Andrew Beattie - Lane Cove Rd Ramp - ID is MP09_0049 MOD 1

Bicycle NSW Submission

Exhibition of Lane Cove Rd Ramp Environmental Assessment

Bicycle NSW has reviewed the Lane Cove Rd Eastbound Onramp Modification Environmental Assessment to provide feedback to help ensure that adequate provisions have been made to accommodate and encourage the use of bicycles for a variety of purposes.

Figure 1: Existing situation (assuming bicycle access to M2)

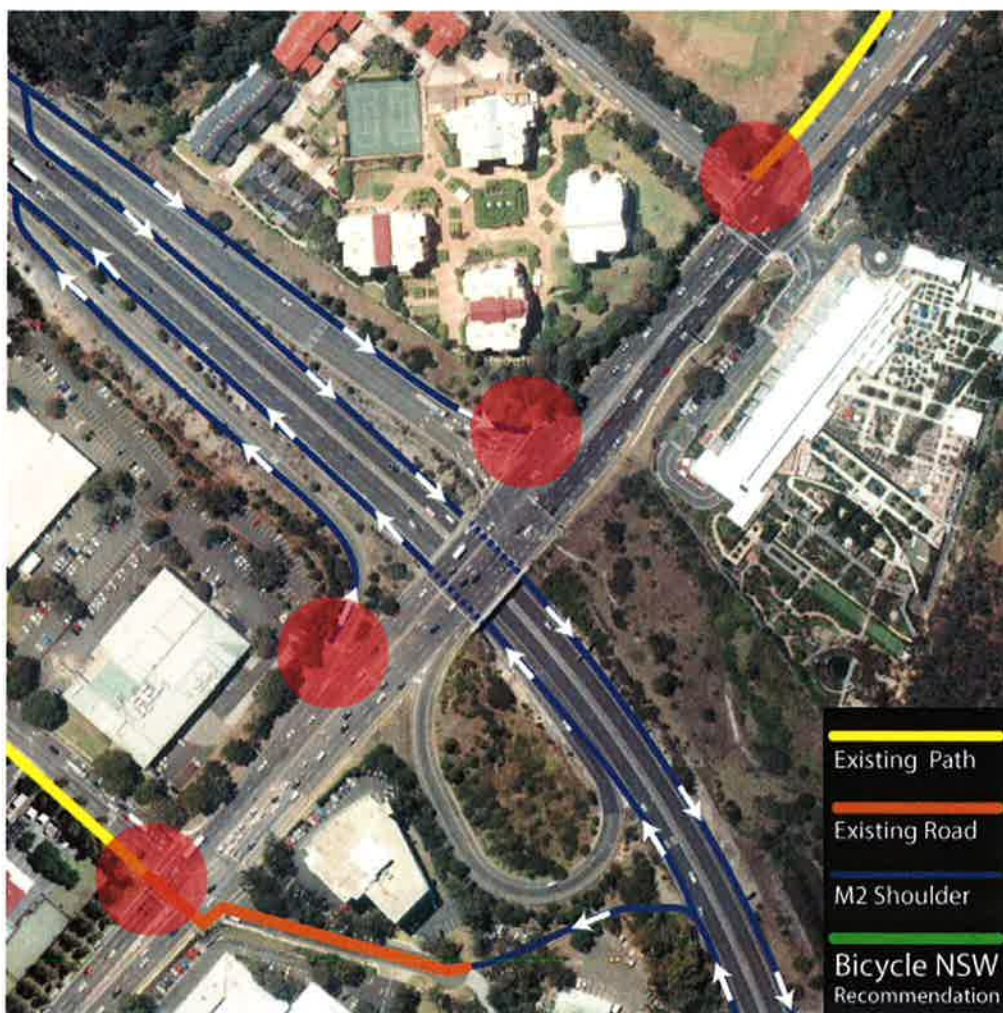
The current intersection of the M2 and Lane Cove Rd provides poor connectivity between nodes of the bicycle network (red circles in Figure 1). Northbound bicycle facilities are non-existent and Southbound facilities consist of an on-road bicycle lane which is crossed by a high-speed freeway on-ramp.

These facilities do not provide a sufficient level of safety for even the most experienced of bicycle users. The inadequacy of the facility becomes particularly clear when considering children or other less-proficient bicycle users. The long, sweeping on-ramps encourage motor-vehicles to maintain speed in preparation for joining the motorway which creates a dangerous environment for pedestrians and bicycle users.

Figure 2: Recommended Connection from Fontenoy Rd to M2

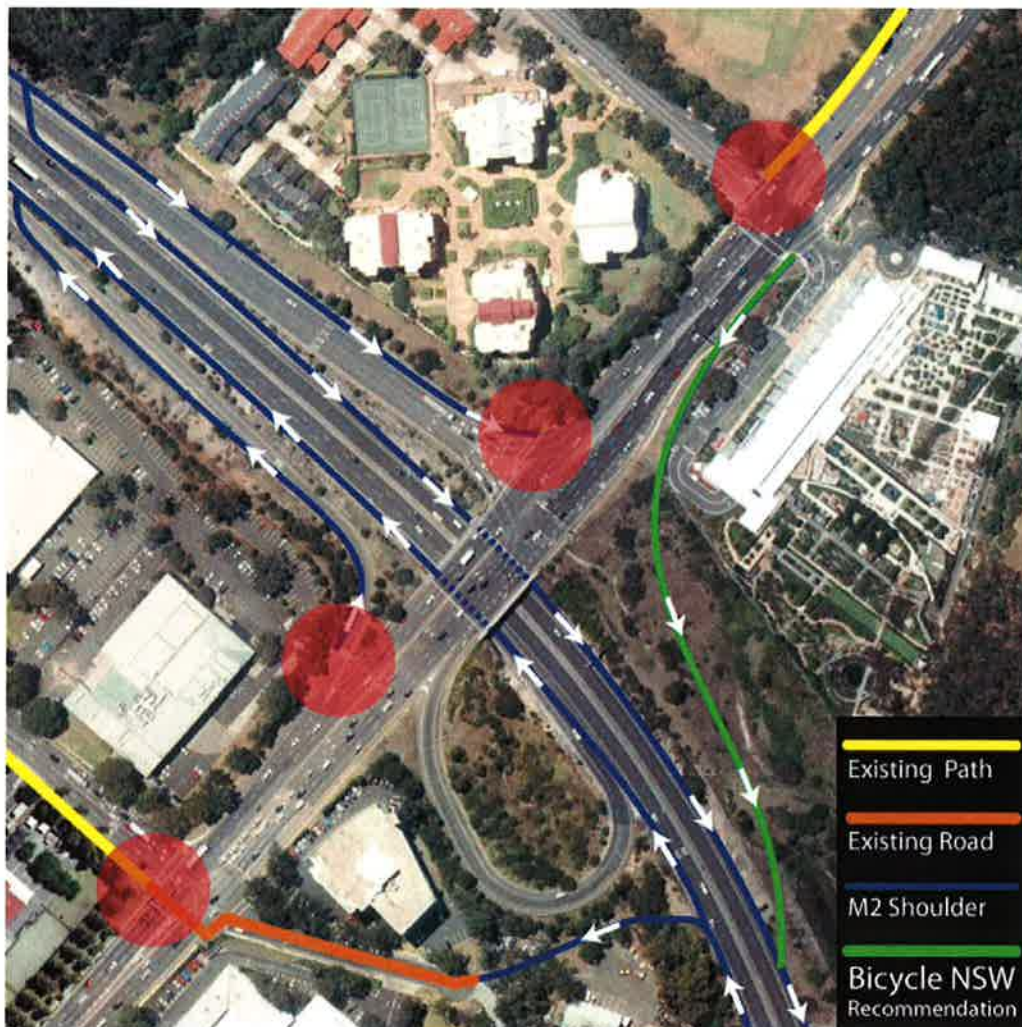
The Plan does not mention how the proposed ramp plans to provide Southbound bicycle access from Lane Cove Rd to the M2 shoulder. This is an essential connection that allows bicycle users to bypass the dangerous North Ryde CBD and join the Epping Rd shared-use path.

Bicycle NSW recommends that **The Plan** includes appropriate facilities for bicycle users travelling Westbound on Lane Cove Rd or exiting Fontenoy Rd to access the M2 using the new Lane Cove Rd Ramp as shown in Figure 2.

The most appropriate way to provide this facility is to provide a grade-separated path on the South side of Lane Cove Rd from Fontenoy Rd to the new Lane Cove Rd Ramp. As the on-ramp leaves Lane Cove Rd, a transition ramp should be built to provide bicycle access to the shoulder of the M2.

Figure 3: Recommended Shared Path on Lane Cove Rd

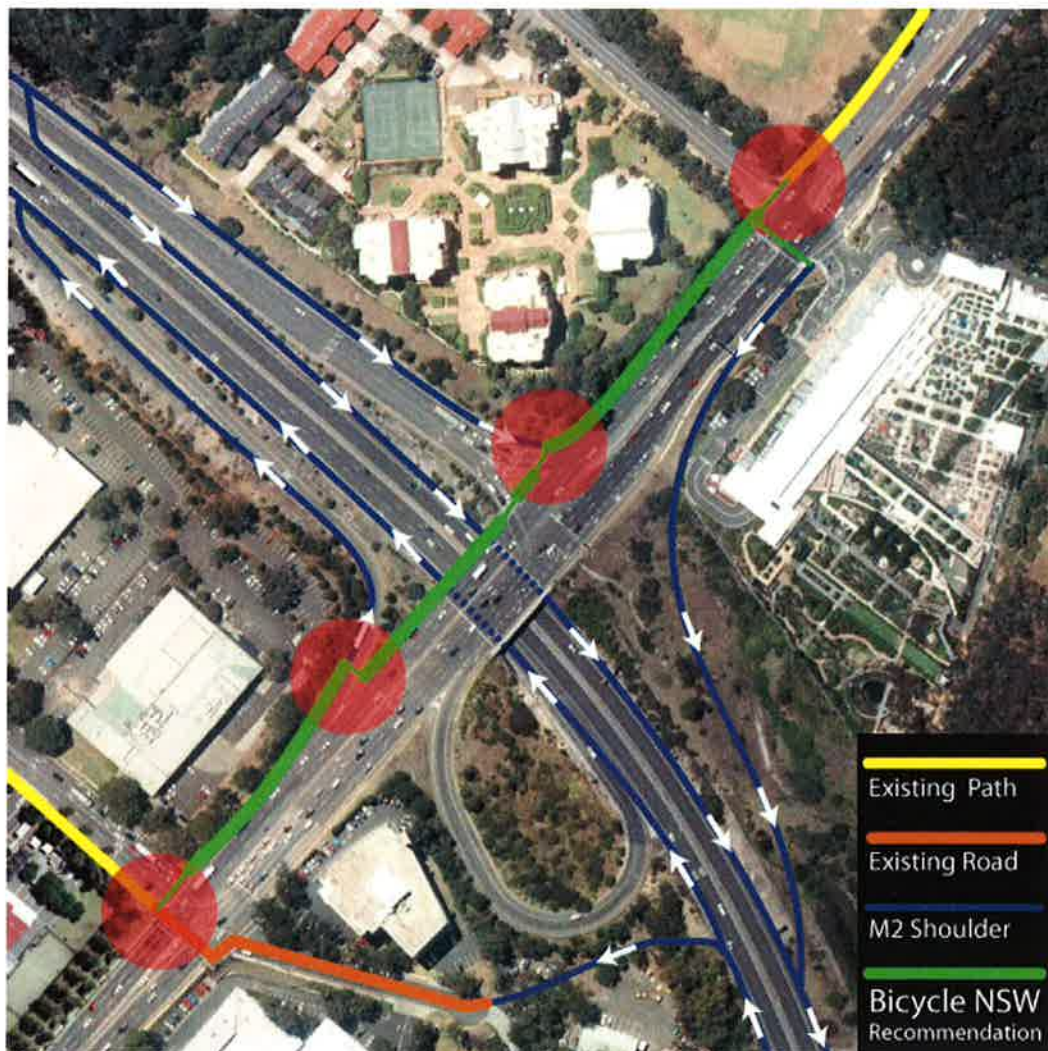
Northbound bicycle users will continue to be forced to use Lane Cove Rd which is a dangerous, high-speed, high-traffic environment without a bicycle facility. Southbound bicycle users will be adversely impacted by the addition of a second high-speed vehicle crossing as outlined in **The Plan**.

Bicycle NSW recommends that **The Plan** includes the construction of a bi-directional shared path on the Western side of Lane Cove Rd between Fontenoy Rd and Talavera Rd as shown in Figure 3.

The recommended shared path would fill a missing link between a number of important routes including:

- the shared-use path between Yanko Rd and Fontenoy Rd (yellow).
- the shared-use path on Talavera Rd (yellow).
- the M2 shoulder (blue).
